SUBJECT: Change Proposal PE-22, Timer Access
and Cover

COMPANY NAME Perkin-Elmer Corp.		ENGINEERING STUDY <input type="checkbox"/> CHANGE PROPOSAL <input checked="" type="checkbox"/>		Proposal No. P-E-22	
DATE Feb. 22, 1962		AFFECTS: WSPO <input checked="" type="checkbox"/> PROJECT <input type="checkbox"/>			
NAME OF MAJOR COMPONENT Tracker		PART OR LOWEST SUBASSEMBLY Front Cover Assy.		PART NO. & MODEL OR TYPE P/N 151-0114	
TITLE OF PROPOSAL: Timer Access and Cover					
NATURE OF PROPOSAL: Modification of P/N 151-0114 Front Cover Assy. to provide a 2-3/4" access hole and a light-tight quick disconnect cover.					
REASON FOR PROPOSAL: To facilitate timer access for "Hacking". REF: Suggestion LAU-49-61M dated 11 April 1961 NOTE: Deviation from suggestion required to: 1. Insure Tracker cover rigidity at access hole. 2. Provide greater rigidity to proposed access cover. 3. Provide more positive "Light-Proofing".					
E S		ESTIMATED COST AND TIME INVOLVED: ADDITIONAL FUNDING REQUIRED: N/A

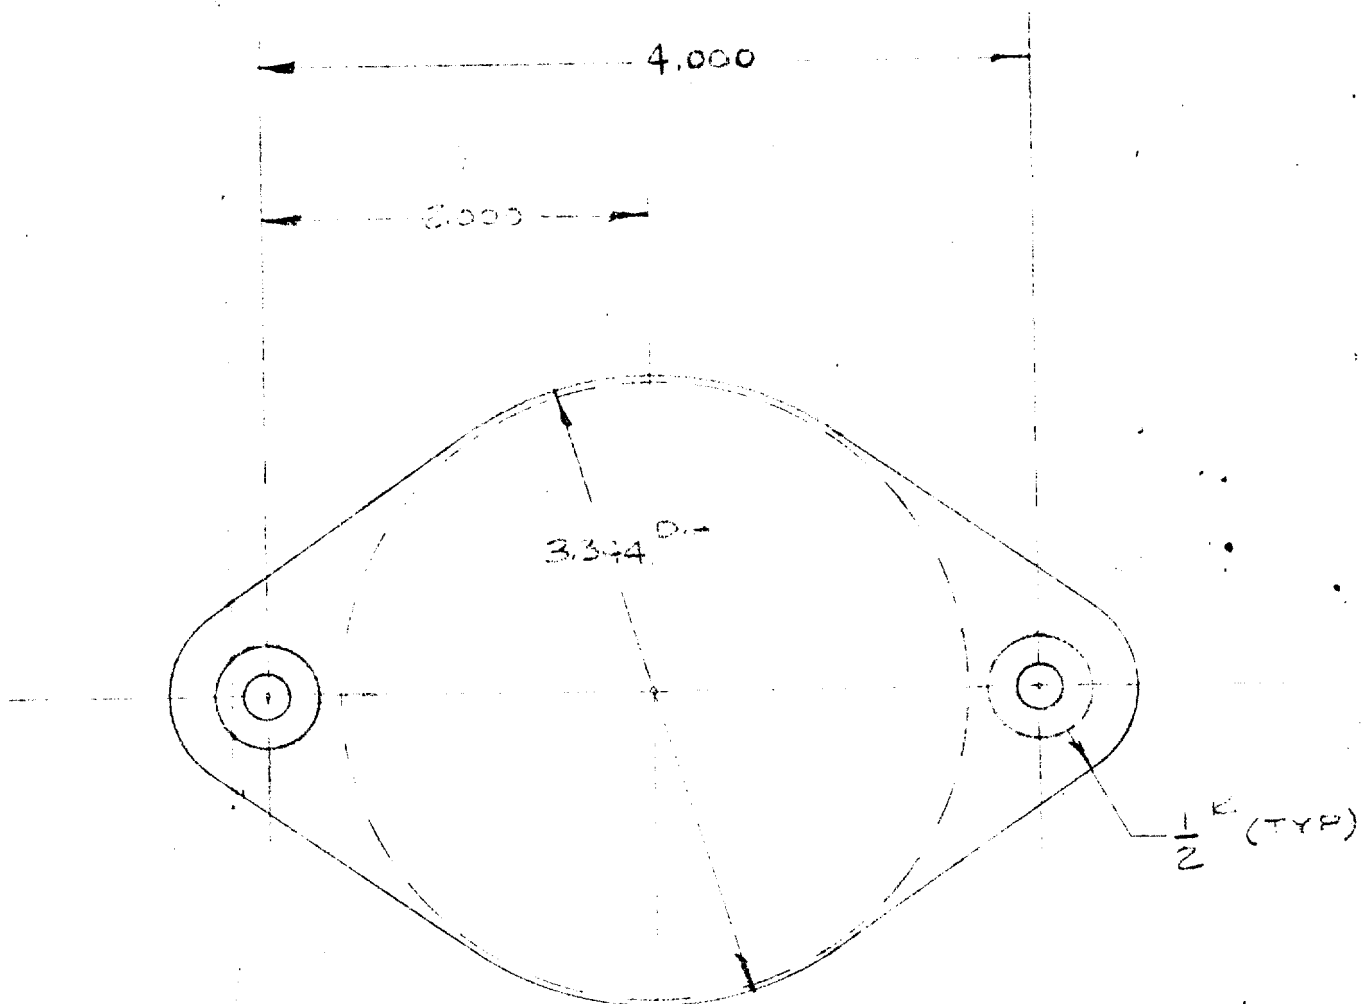
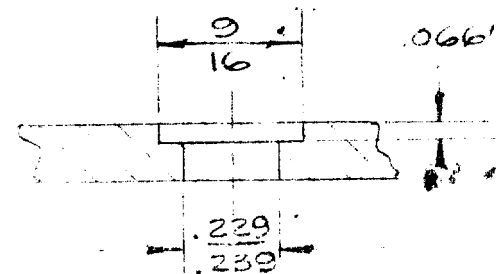
C P		ESTIMATED COST FOR KITS OR PARTS: \$60.00/kit (including 2 sets of tools) ADDITIONAL FUNDING REQUIRED:			
ITEMS AFFECTED BY PROPOSAL: P/N 151-0114 Cover Assy.					
Safety <input type="checkbox"/>	Mission Effectiveness <input type="checkbox"/>	Performance <input type="checkbox"/>	Operating Procedure <input checked="" type="checkbox"/>	Interchangeability <input type="checkbox"/>	Weight or Weight & Balance <input type="checkbox"/>
Tools & Support Equipment <input type="checkbox"/>	Maintenance Procedure <input type="checkbox"/>	Service Life <input type="checkbox"/>	Flight Manual <input type="checkbox"/>	Maintenance Manual <input type="checkbox"/>	
EST. MAN/HR. REQ'D. TO ACCOMPLISH CHANGE IN FIELD 1 Hr.					
SOURCE OF PARTS FOR KIT contractor			AVAILABILITY 6-8 WEEKS AFTER APPROVAL		
DISPOSITION OF SPARES AFFECTED N/A			STATINTL <input type="checkbox"/>		
INITIATED BY: customer Approved LAU-49-61M			APPROVED: WSPO <input type="checkbox"/> Approved LAU-49-61M
